**SERVICE BULLETIN**

**N° 139-718**

**ATA 93 – OPLS KIT COMPLETION**

This Service Bulletin is issued in order to provide the necessary instruction on how to perform the installation of the CPU P/N IS00519-B of kit OPLS P/N 4G9360F00211.

**Figure 1**

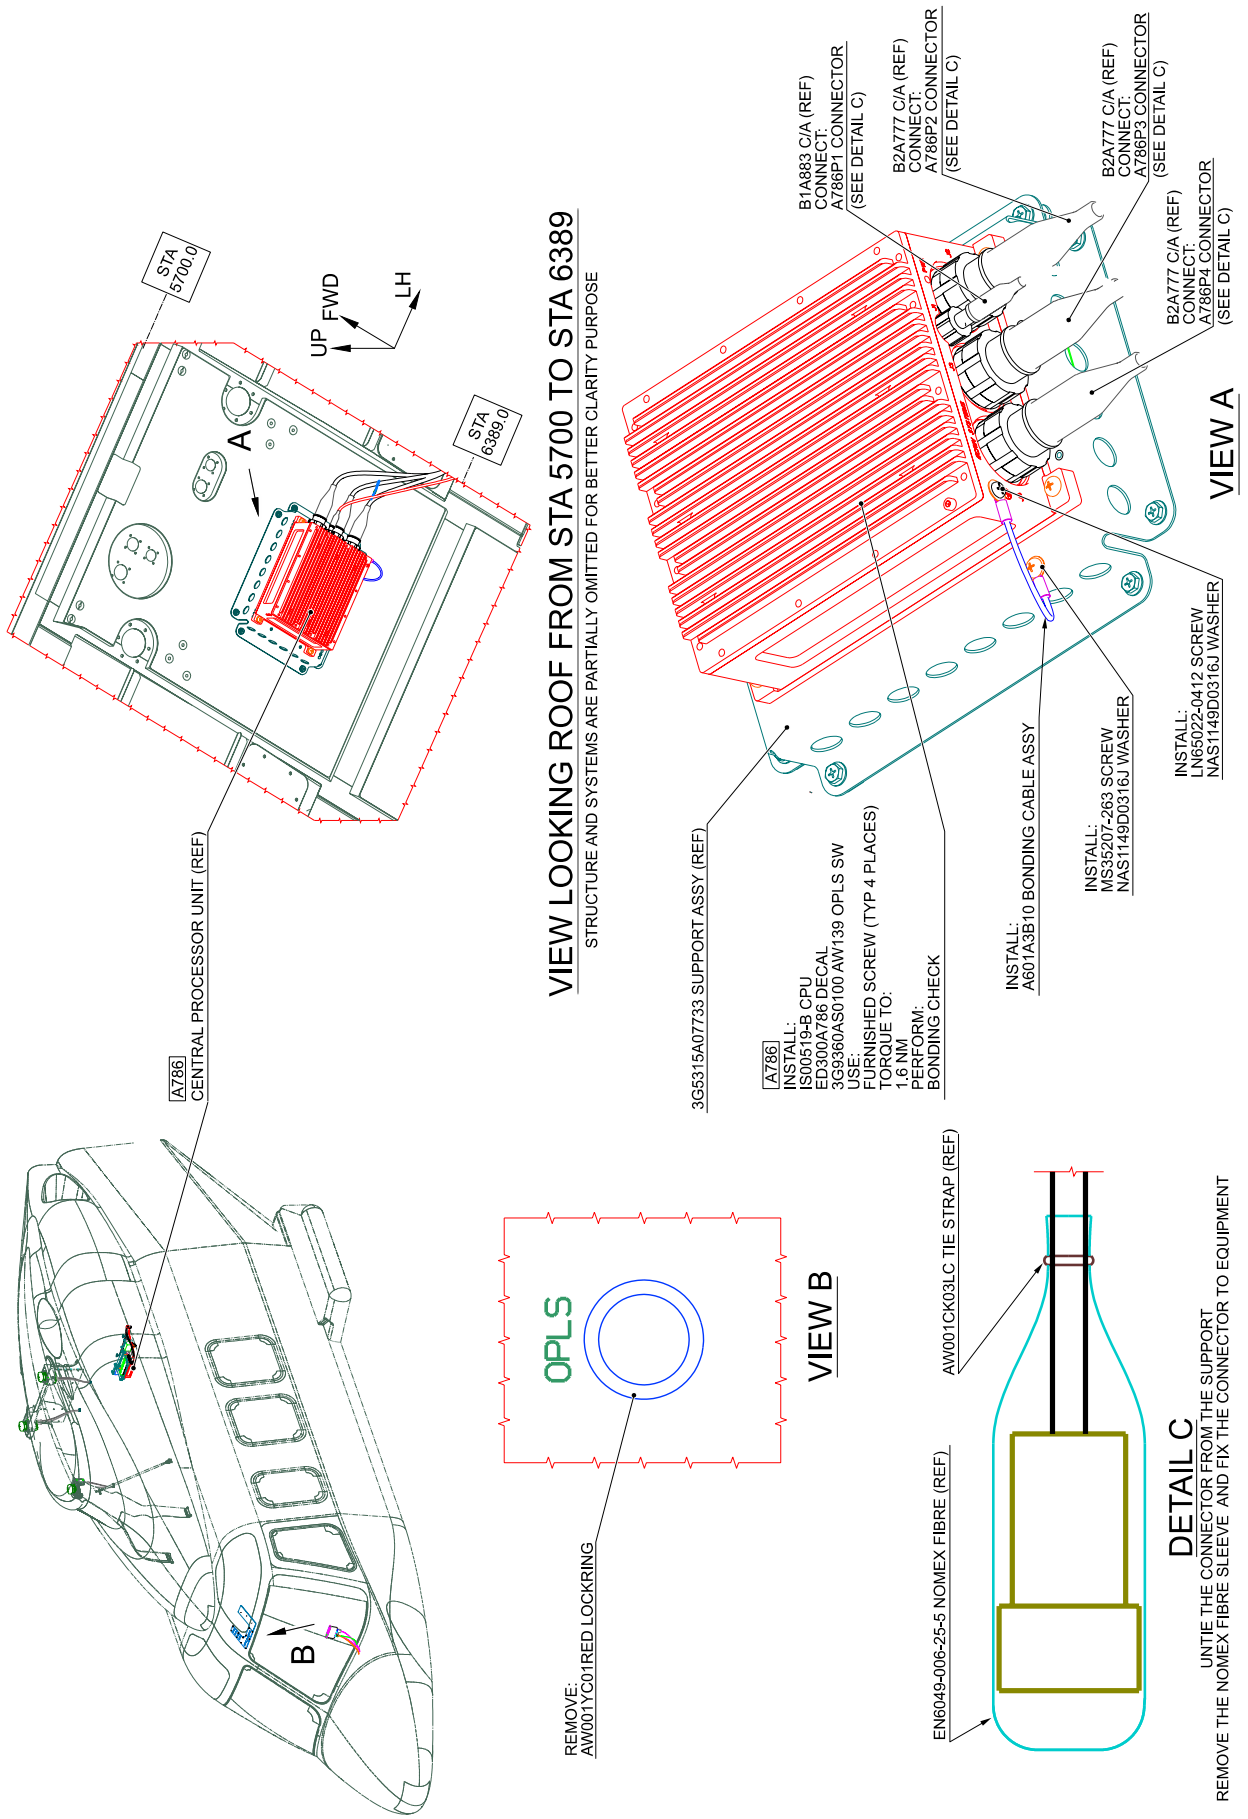
- 2.1 With reference to Figure 1 View A, install the Central Processor Unit P/N IS00519-B on the support assy P/N 3G5315A07733 by means of n°4 furnished screws. Torque to 1.6 Nm.

- 2.2 With reference to Figure 1 View A, install the bonding cable assy P/N A601A3B10 on the support assy P/N 3G5315A07733 by means of washer P/N NAS1149D0316J and screw P/N MS35207-263.

- 2.3 With reference to Figure 1 View A, install the bonding cable assy P/N A601A3B10 on the Central Processor Unit P/N IS00519-B by means of washer P/N NAS1149D0316J and screw P/N LN65022-0412.

- 2.4 In accordance with AMP DM 39-A-11-00-01-00A-720A-A and with reference to Figure 1 View A, install the decal P/N ED300A786 on the Central Processor Unit P/N IS00519-B.

- 2.5 With reference to Figure 1 View A, perform the bonding check between the Central Processor Unit P/N IS00519-B and the support assy P/N 3G5315A07733. The resistance measured must not exceeds the value of 2.5 milliohms.

- 2.6.3 If bonding values are still out of the acceptable limits, remove the Central Processor Unit P/N IS00519-B and reinstall it interposing a conductive gasket P/N A519A-A000 between the Central Processor Unit P/N IS00519-B and the support assy P/N 3G5315A07733.

- 2.7 With reference to Figure 1 View A and Detail C, remove the existing caps from the electrical connectors A786P1, A786P2, A786P3 and A786P4.
- 2.8 With reference to Figure 1 View A, connect the electrical connectors A786P1, A786P2, A786P3 and A786P4 to the receptacles of the CPU P/N IS00519-B.

3. With reference to Figure 1 View B, remove the lock ring P/N AW001YC01RED from the CB panel.
